RELOAD REPORT

Catawba Unit 2 Cycle 6

Duke Power Company  
Nuclear Generation Department  
Nuclear Engineering Section

FIGURE 2.1-1a

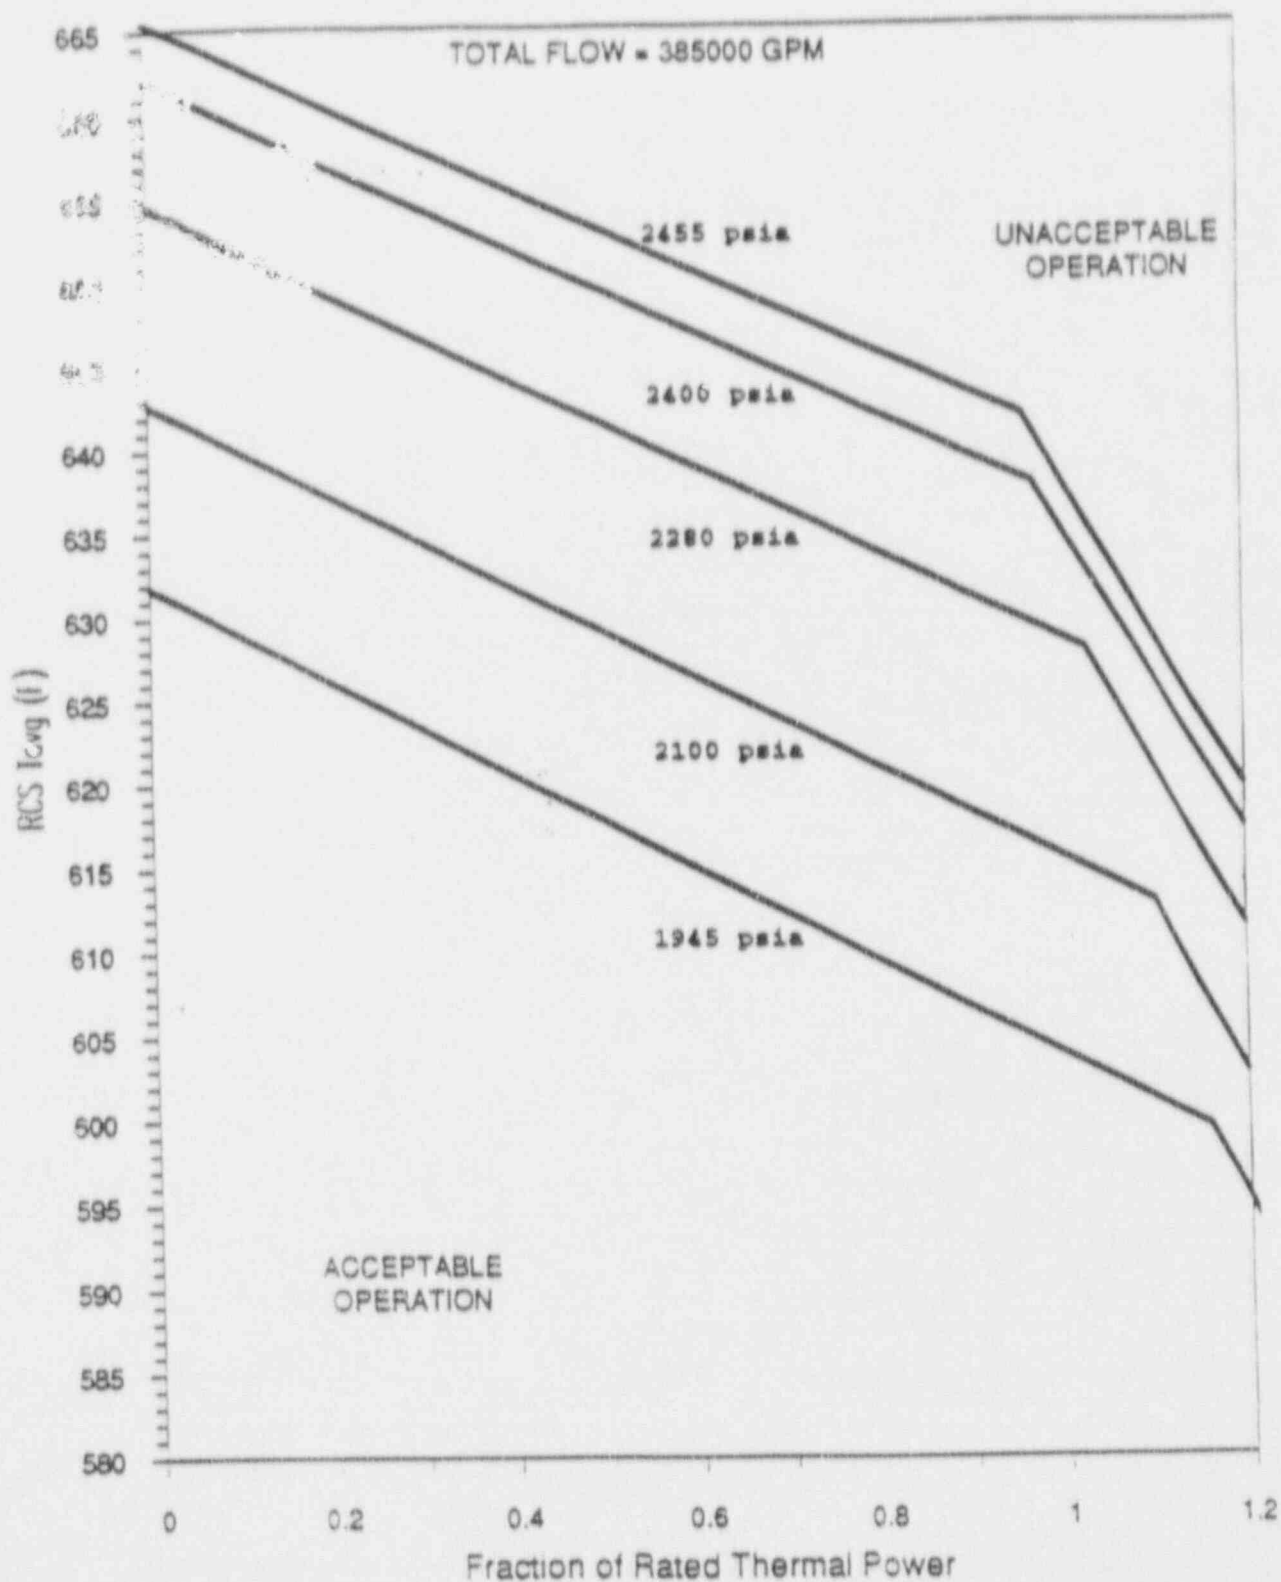
REACTOR CORE SAFETY LIMITS - FOUR LOOPS IN OPERATION, ~~UNIT 1~~

Delete

Figure 3.2-1 Reactor Coolant System Total Flow Rate Versus  
Rated Thermal Power - Four Loops in Operation  
~~(Unit 1)~~

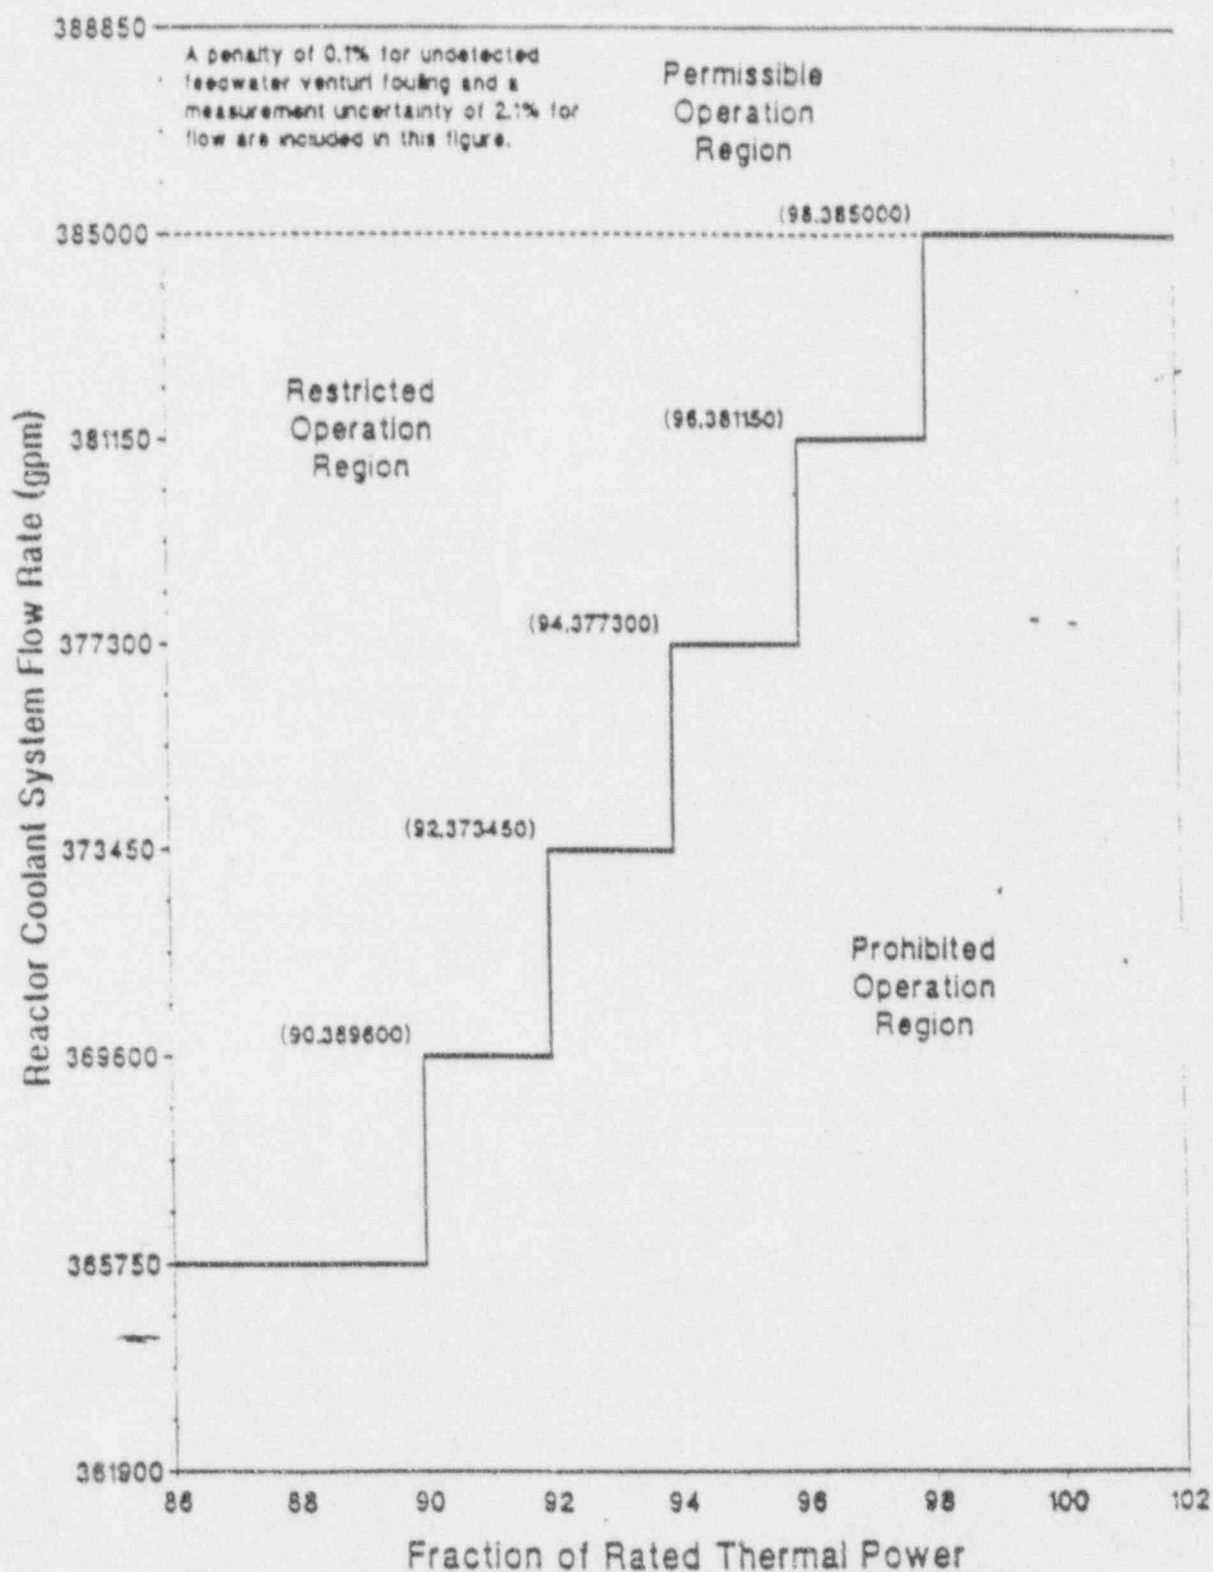
<u>Specification</u>	<u>Description of Change</u>
3/4.1.3.5	revised shutdown bank insertion limits to reflect a minimum rod withdrawal limit of 222 steps and a maximum rod withdrawal limit of 230 steps
3/4.1.3.6	revised control bank insertion limits to reflect a minimum rod withdrawal limit of 222 steps and a maximum rod withdrawal limit of 230 steps
3/4.2.1	revised AFD limits for Cycle 6 operation
3/4.2.2	revised for Cycle 6 operation to reflect a change in the heat flux hot channel factor $F_{\text{H}}$ methodology
3/4.2.3	revised for Cycle 6 operation to reflect a change in the nuclear enthalpy rise hot channel factor $F_{\Delta\text{H}}$ methodology
3/4.2.5	moved figure 3.2-1 from COLR to Technical Specifications
